PLAN COMMISSION AGENDA
Monday, May 19, 2025 at 6:00 p.m.
Caledonia Village Hall – 5043 Chester Lane
Caledonia, WI 53402

PLAN COMMISSION REPORT

Proposal: Building, Site, & Operation Plan Review

Description: Review of a request to approve a building, site, and operation plan for the construction and utilization of a $\pm 6,713$ square foot industrial building for the property located directly north of 4005 Quick Drive.

PLAN TITLE:
**LANDSCAPE
PLAN**

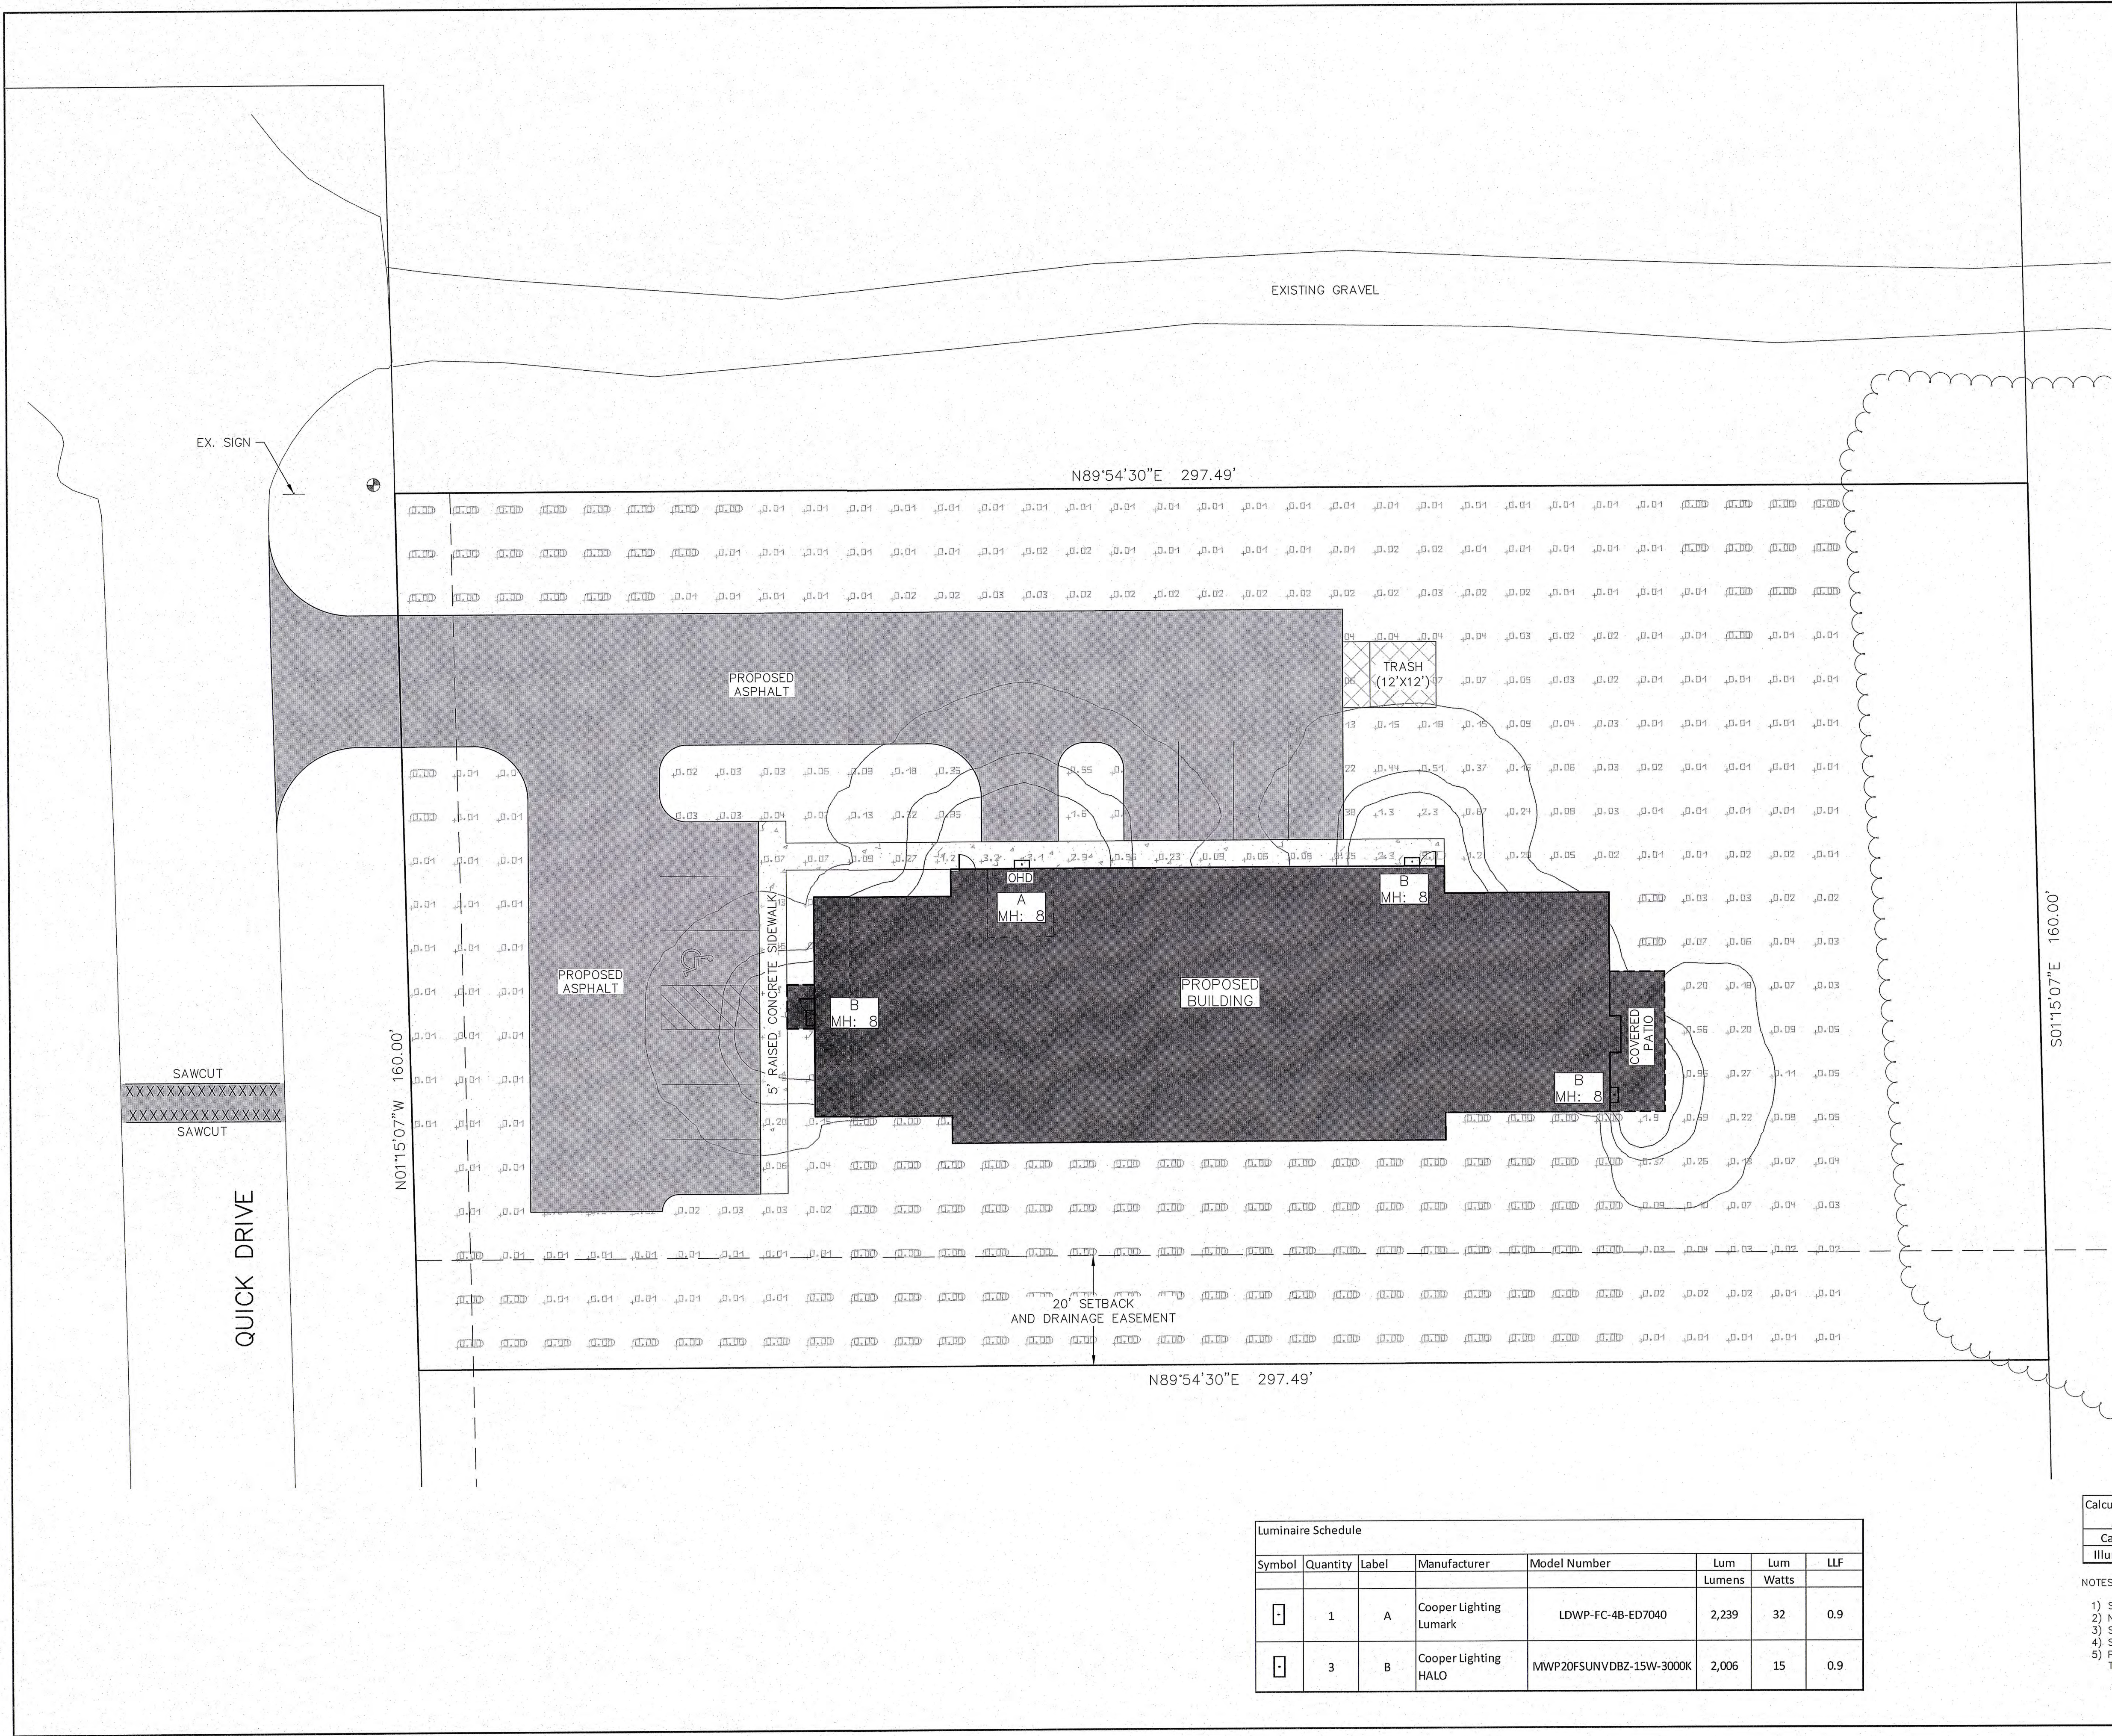
The landscaping plan meets Village requirements. With 160 feet of frontage along Quick Drive, four street trees are required and provided.

To better screen the overhead door from Storage Drive, staff suggests additional plantings along the northwest lot line as stated earlier in this report.

Landscaping consisting of various shrubs and plantings is shown on three sides of the building and complies with code.

PLAN TITLE:
**LIGHTING
PLAN**

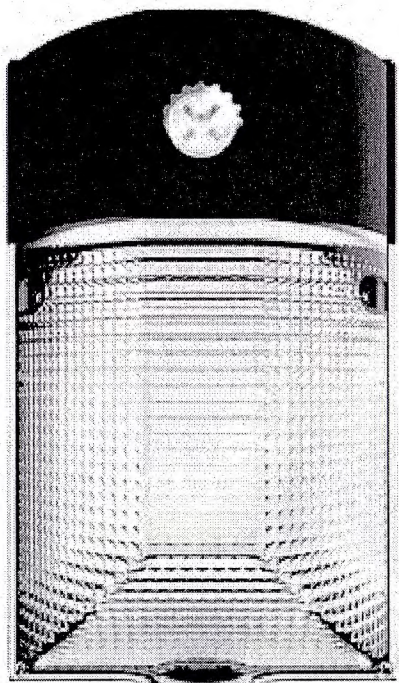
The applicant has submitted a photometric plan demonstrating that site lighting will comply with the Village's lighting ordinance, ensuring no more than $\frac{1}{2}$ foot-candle of light crosses the lot line. All light fixtures must comply with exterior lighting standards and be installed to prevent glare on neighboring properties. The use of Light Fixture B over the overhead door is not shielded. Staff recommends modifying the light fixture to include a shield to reduce glare and comply with code.
